S E R V I C E N O T E

4268A 120Hz/1KHz Capacitance Meter

Serial Numbers: JP1KF00000 / JP1KF00196

Modification to prevent missing an external trigger signal.

Figure 1

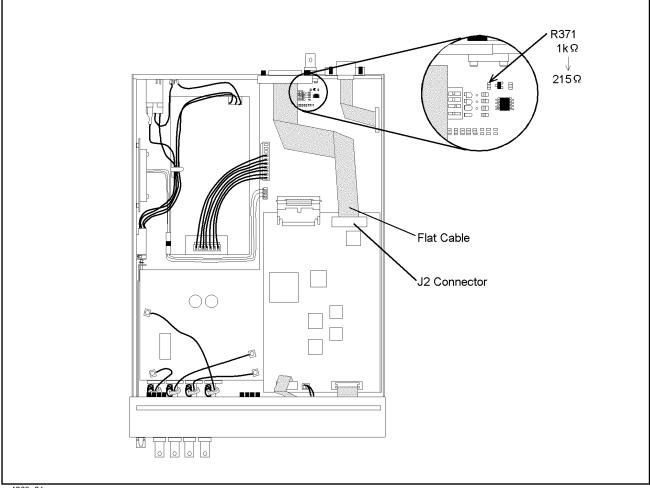
A trigger may not be generated even though a correct external trigger signal (less than 0.5 V TTL low level) is inputted to the 4268A, due to insufficient margin for TTL signal threshold level.

This problem will be corrected by replacement of a SMD resistor. See Figure 1 and perform as following steps to replace the R371 1 kohm SMD resistor on A1 board with a 215 ohm one.

- 1. Remove the outer cover.
 - 1-1. Disconnect the power cable.
 - 1-2. Remove the 2 outer cover screws from the rear panel.
 - 1-3. Slide off the outer cover toward the rear.
- 2. Disconnect a Flat cable from the J2 connector to make a working area.
- 3. Remove the R371 1 kohm SMD resistor.
- 4. Solder the 215 ohm SMD resistor in place of original one.
- 5. Connect the Flat cable to J2 connector.
- 6. Install the outer cover and tighten the screws.
